DRAINAGE @ INTERSECTION
SCHUYLER-WINDSOR ROAD
SLIGO PARK HILLS
SCALE 1"=30'
APRIL 1955
FILE 13-408

CONTRACT NO. 0317-DE

WASHINGTON SUBURBAN SANITARY COMMISSION

SILVER SPRING DISTRICT
STORM DRAINAGE
SCHUYLER ROAD AT WINDSOR STREET

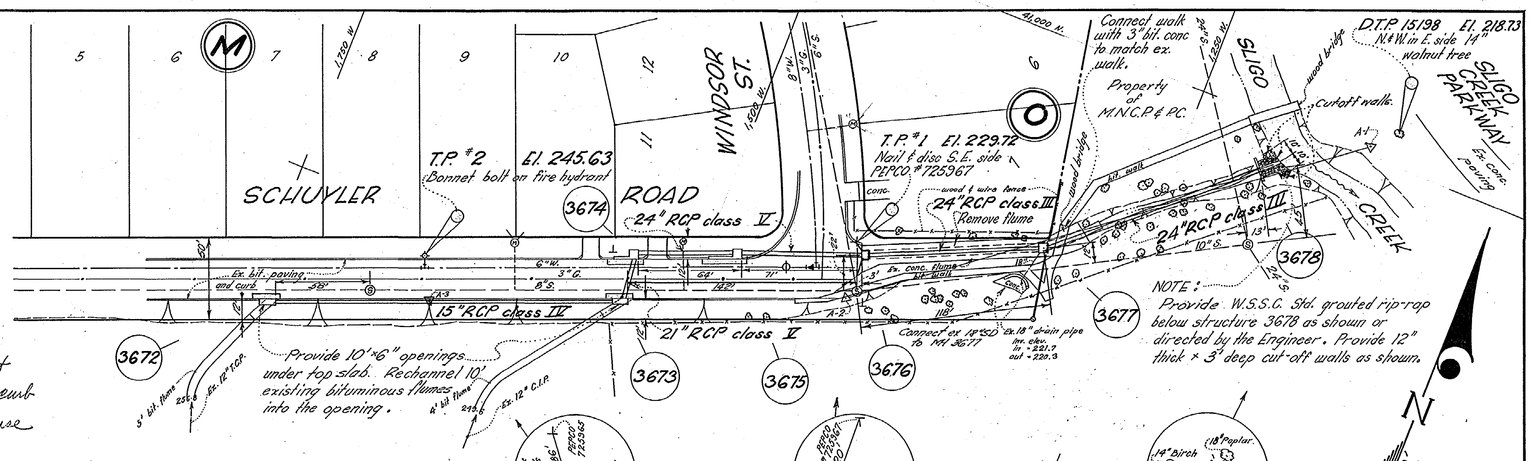
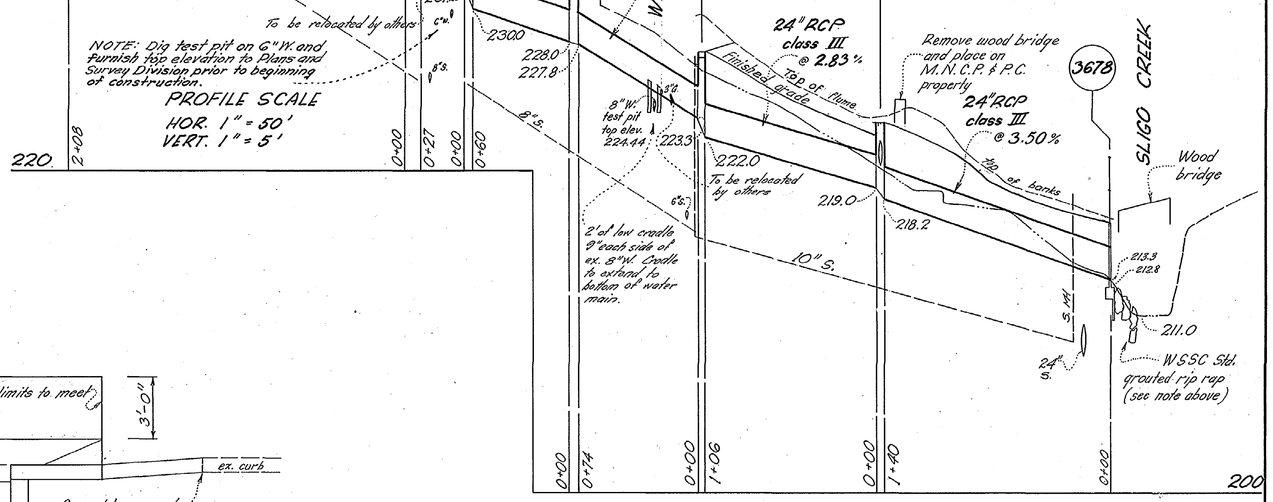
At request of Construction Division, Inlet 3675 type reinsed to A-20 as result of 24" pipe being installed too close to curb due to incorrect stakeout — to permit use of B type inlet.
